RotorSport UK Ltd

Service Bulletin

| SB No.: 042 Iss1 | CCAR No.: None | Classification: |
| Aircraft type & model (applicability) RotorSport UK Calidus | Aircraft serial Nos. effected RSUK/CALS/all | OPTIONAL or RECOMMENDED or MANDATORY |

Fuse-holder location on the bulkhead

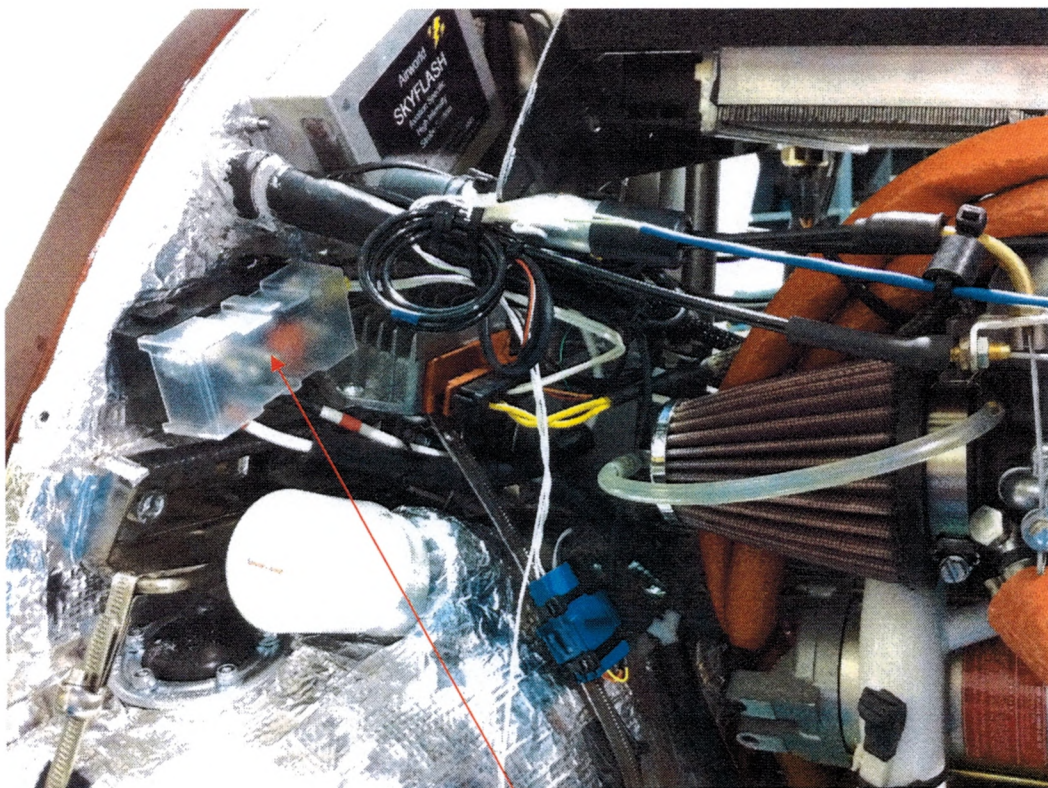
The starter circuit of Calidus aircraft is protected by a 80A fuse. In the German market there have been a small number of fuse failures during starting, this being due to the marginal capability of the fuse in cold and difficult conditions. A higher-rated fuse of the same type has now been approved (MC-192) and is offered for fitment to UK-aircraft, either at the next service interval or as a specific task (approx 1 hour)

- 1) To gain access to the fuse-holder it is necessary to remove the upper engine cowling and possibly the mast cowlings, which will require disconnection of the fuel-inlet pipe and its earthing cable. To avoid risk of debris entering the fuel tank cover the exposed fuel inlet with a rag or plastic cap.
- 2) Remove the starboard lower cowling for access to the battery connections. Visibility and access will be made easier if the port lower cowling is also removed.
- 3) Disconnect the battery earth terminal. **THIS IS ESSENTIAL AS INADVERTENT CONTACT BETWEEN THE FUSE TERMINALS, A METAL SPANNER AND THE AIRFRAME WOULD RESULT IN A SHORT-CIRCUIT.**
- 4) Identify the fuse-holder location, either on the bulkhead above the stainless-steel mounting frame at the port side of the aircraft or within the mounting frame on the port side of the engine.

Fuse-holder location within the mounting frame

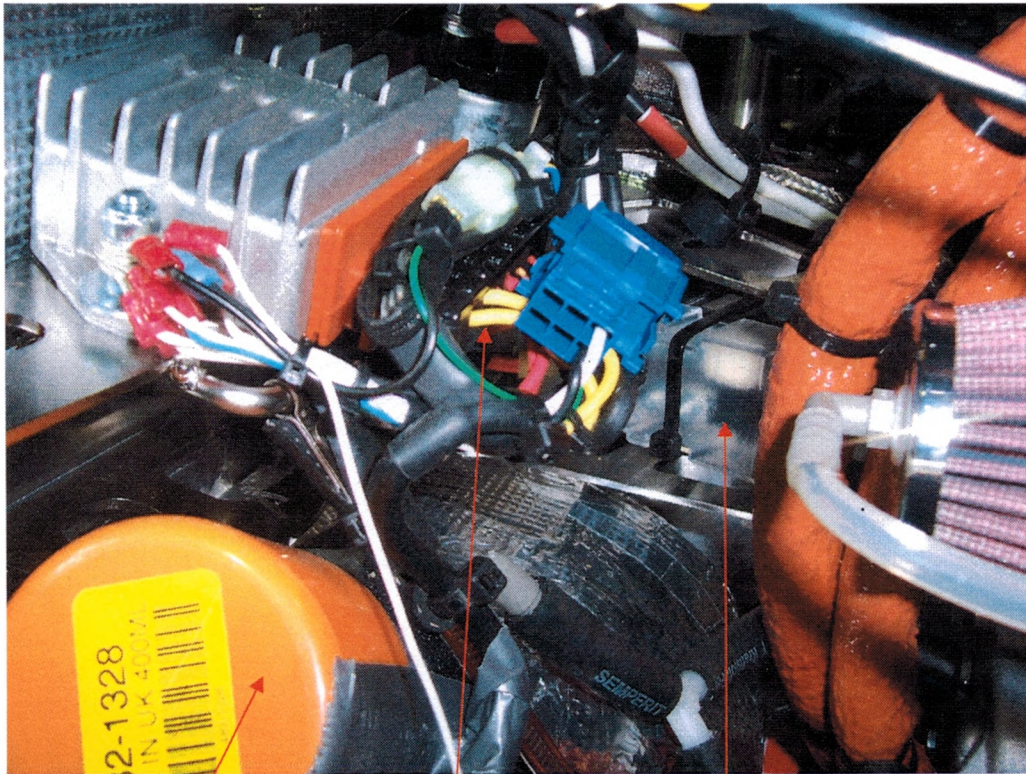
Temporary protective cap Regulator cables Fuse holder with "Safety" cable-tie visible

- 5) Carefully cut as many cable-ties as needed to enable the regulator cables to be pulled to one side and allow access to the fuse holder.
- 6) Cut any "safety" cable-tie around the fuse-holder and unclip the fuse-holder lid.

- 7) Identify the 80A fuse (by its marking) and remove the two nuts/washers retaining it. Discard the 80A fuse.
- 8) Fit the 100A fuse (identified by its marking), replace the two nuts/washers and tighten the nuts to 1.0 – 1.6Nm.

Parts required to implement this service bulletin

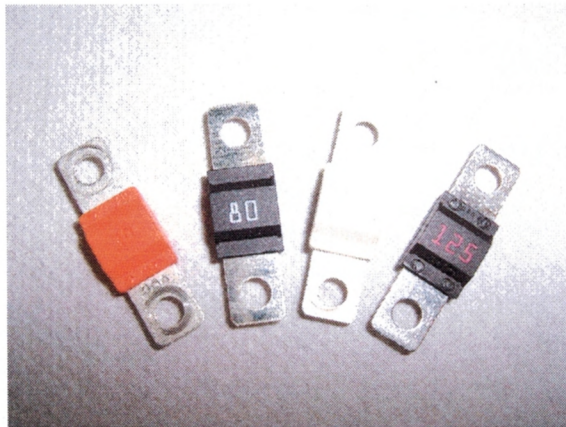
100A fuse RSD4652
 Cable-ties (as required)

Important: Fuse value identified by marked number not by colour
